Authorized Field Change

AFC G-05901

Subject: Check Electrical System Light Stays On, Without Fault Codes Registered, on Certain HPV Models Built Between September 1, 2004 and September 29, 2004

Model: 1300, 3200, 3300, 4200, 4300, 4400, 7300, 7400, 7500, 7600, 8500, 8600

Figure 7 Cut Bridge

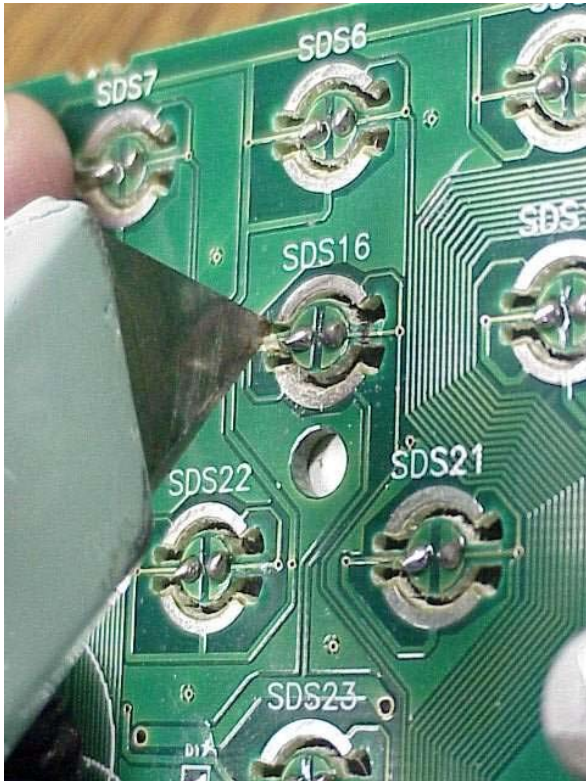
8. The lights are supported by two bridges to the circuit board. Use a sharp knife and cut through one of the bridges (Figure 7).

Figure 9 Remove Lamp

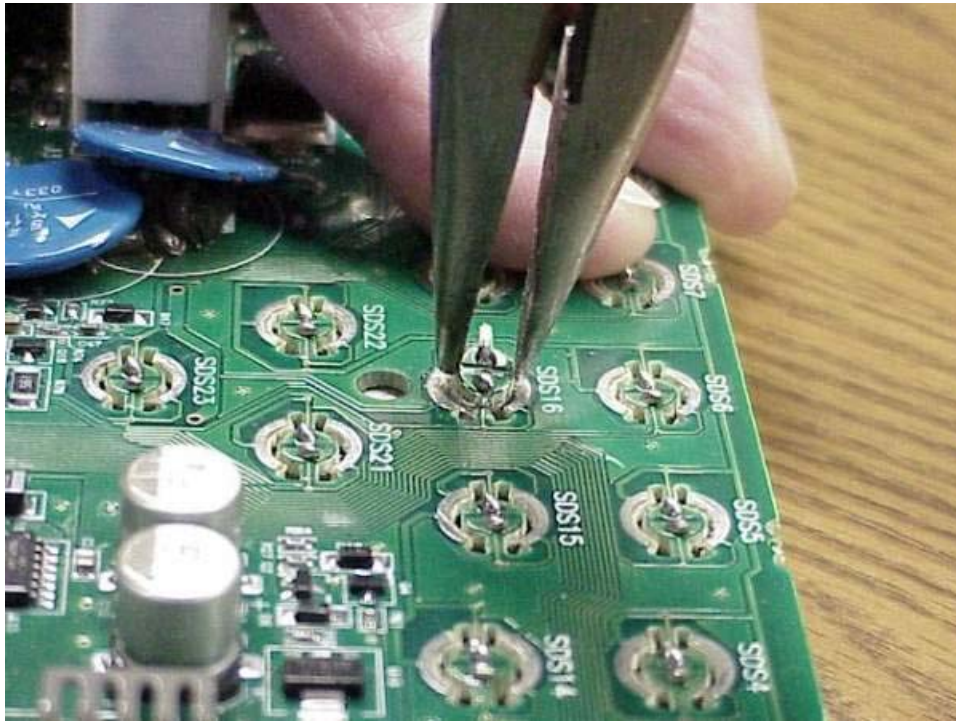
10. Grasp the lamp with long nose pliers and carefully twist the lamp out of the circuit board (Figure 9)
